C.N.227.1997.TREATIES-44 (Depositary Notification)

MODIFICATIONS TO REGULATION NO. 44 ANNEXED TO THE AGREEMENT

PROCES-VERBAL CONCERNING CERTAIN
MODIFICATIONS TO REGULATION NO. 44
ANNEXED TO THE AGREEMENT

Figure 1:
Arrangement for testing a forward-facing device

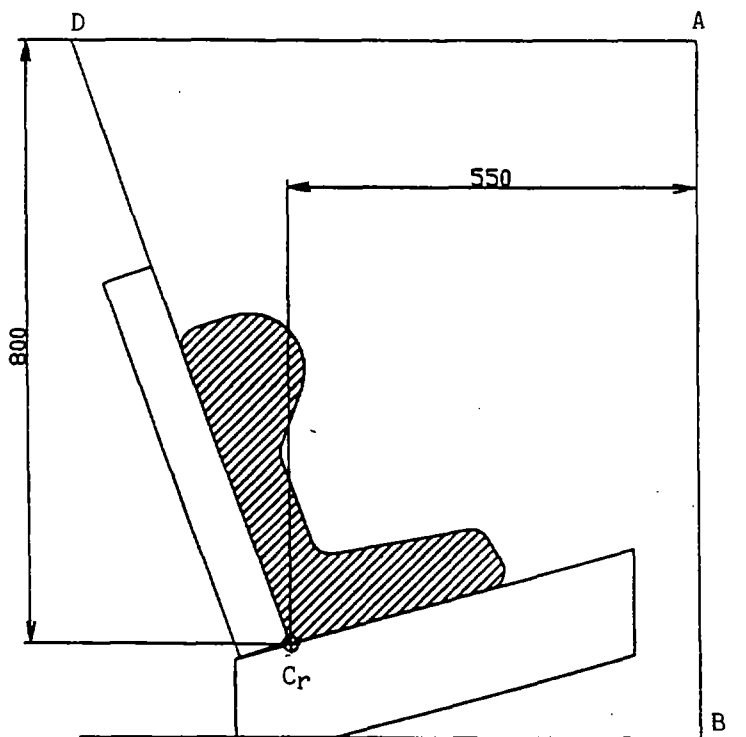
Paragraph 7.1.4.4.1.1., delete the words "groups I, II and III" and figure 1 replace by the following new figure 1:

Figure 2:

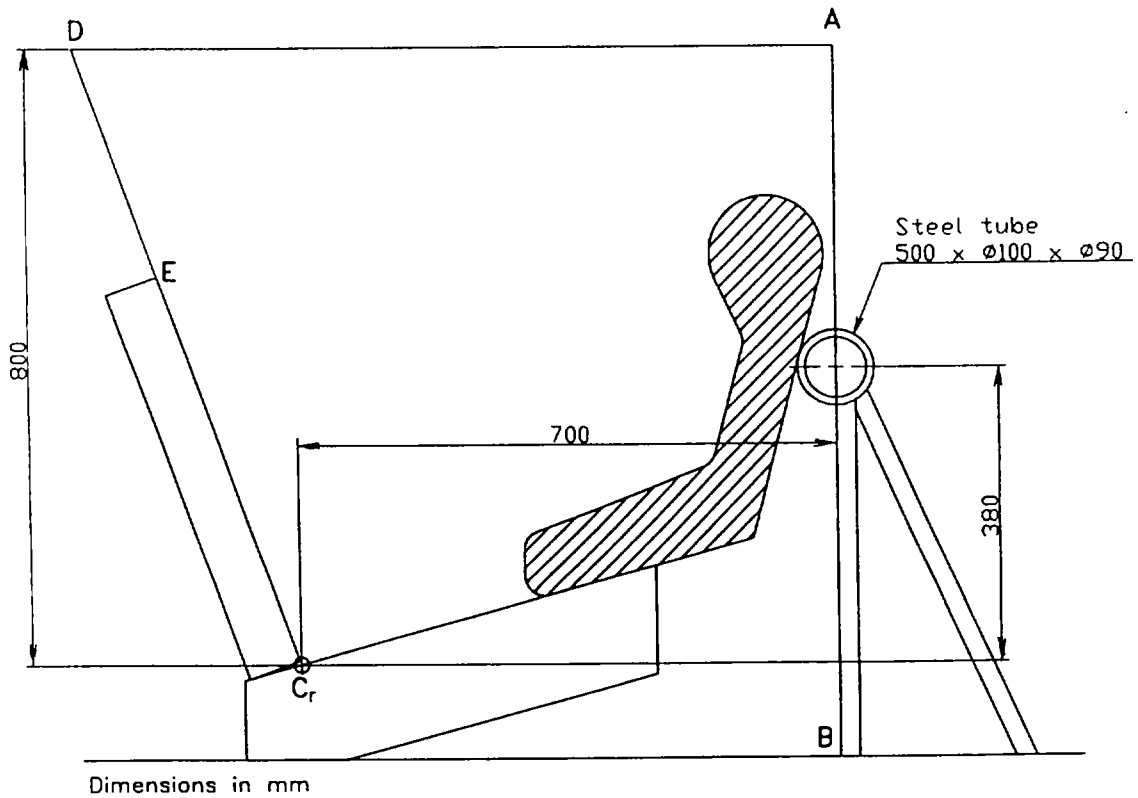
Paragraph 7.1.4.4.1.2.1. Figure 2, replace by the following new figure 2:

Figure 3:

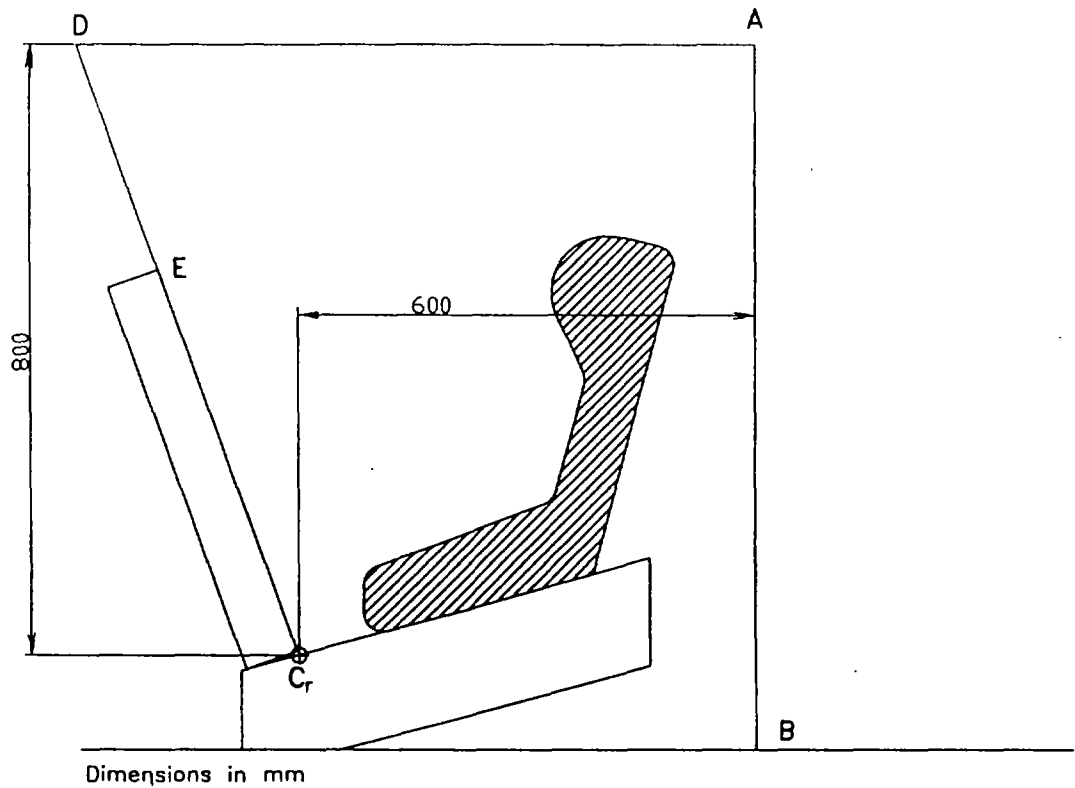
Paragraph 7.1.4.4.1.2.2., Figure 3, replace by the following new figure 3:

Figure 4:

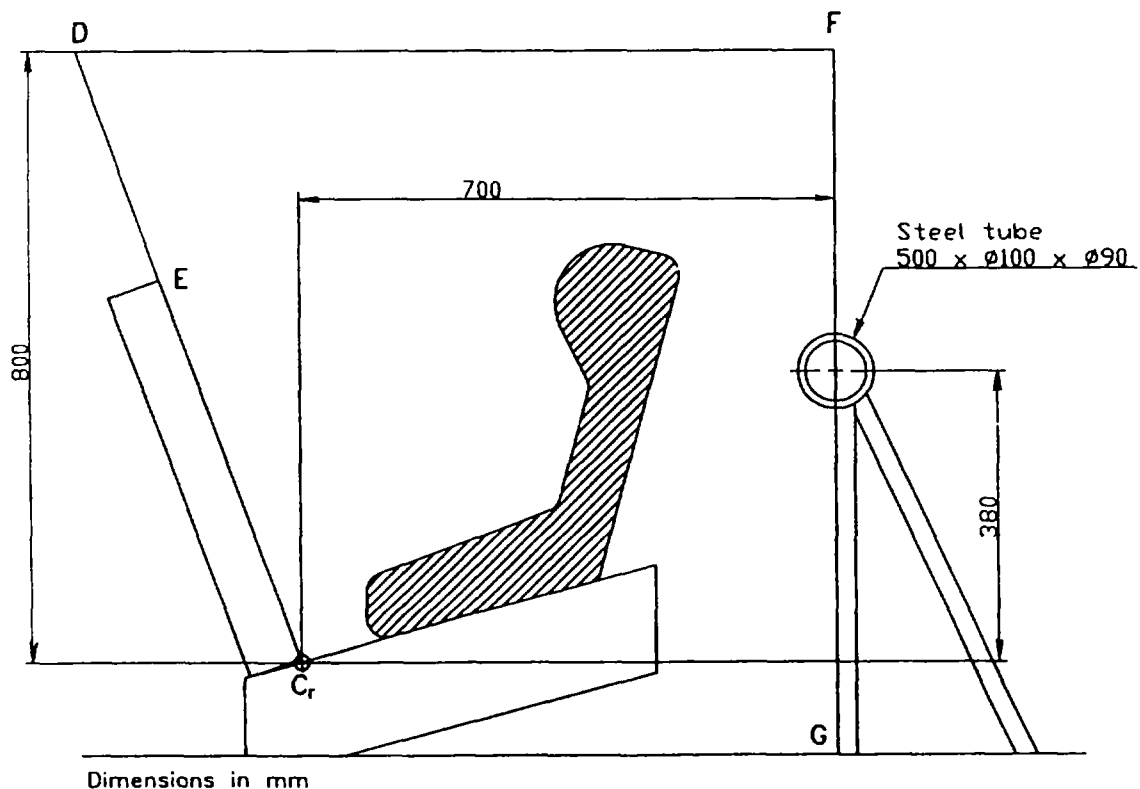
Paragraph 7.1.4.4.1.2.3., amend to read (inserting also a new Figure 4):

"7.1.4.4.1.2.3. Child restraints other than group O not supported by the dashboard:

The head of the manikin shall not pass the planes FD, FG and DE, as shown in Figure 4 below.

Figure 1:
Arrangement for testing a rearward-facing device

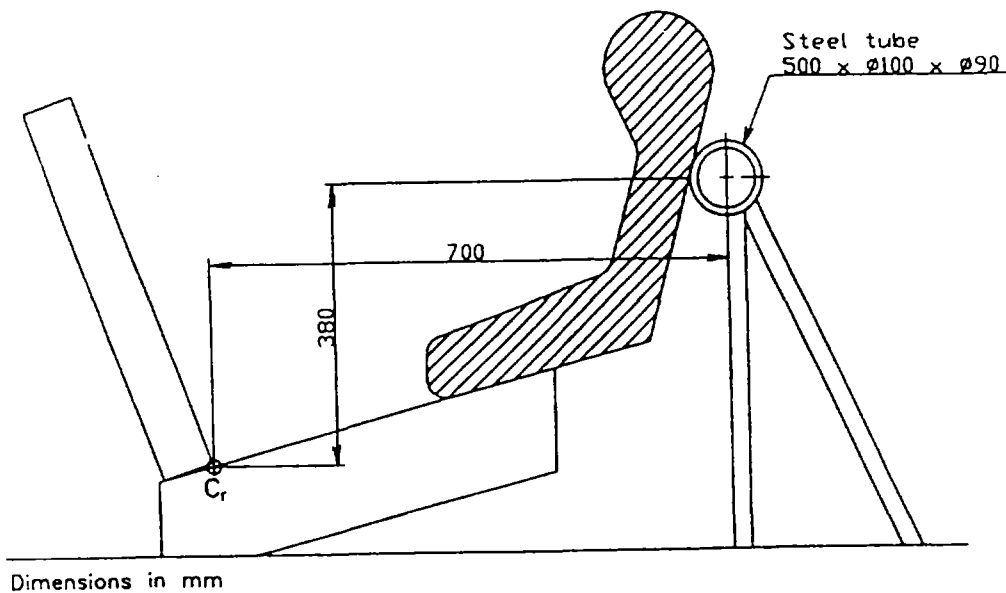
Paragraph 3.2.3., Figure 1, replace by the following new figure 1:

Figure 1:
Dimensions of the seat and the seat cushions

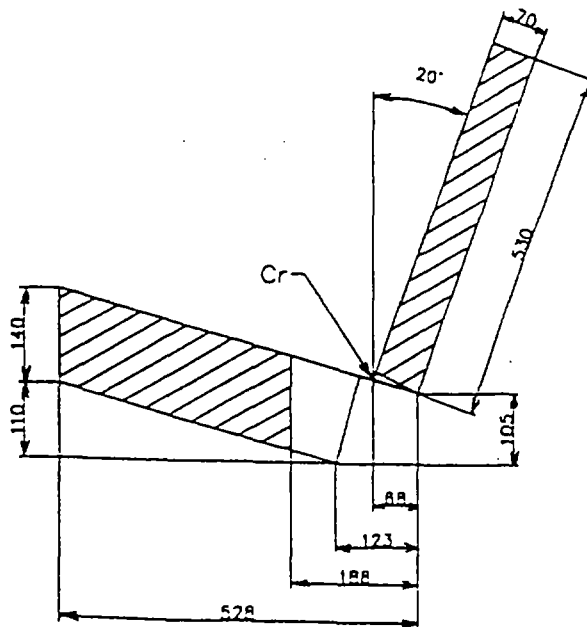
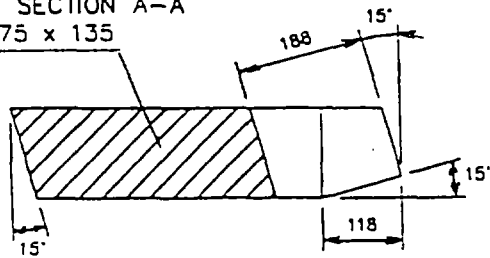
Annex 6-Appendix 1, Figure 1, replace by the following new Figure 1:

SQUARE FOAM BLOCK, SECTION A-A
DIMENSIONS: 800 x 575 x 135

Figure 3:
Dimensions of the cover material

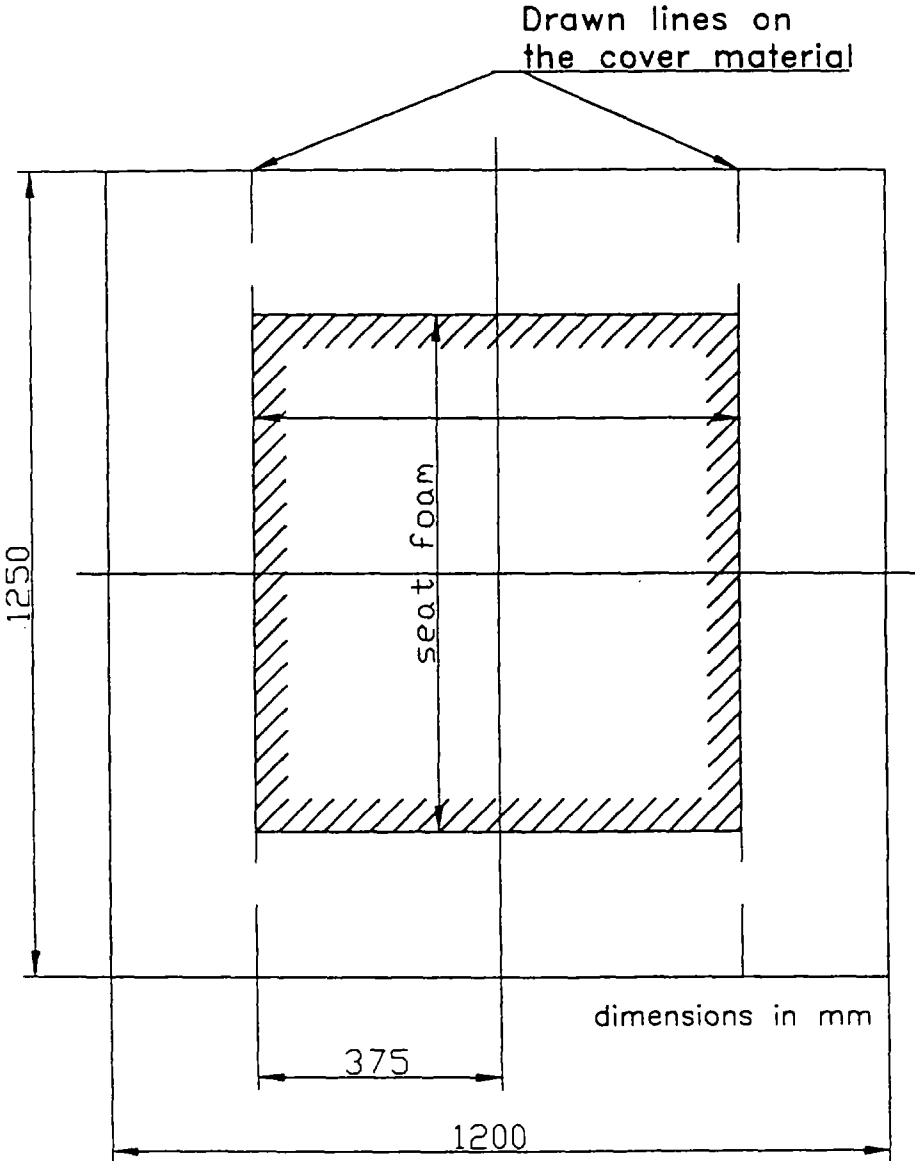
Annex 6-Appendix 1, Figure 3, replace by the new following figure 3:
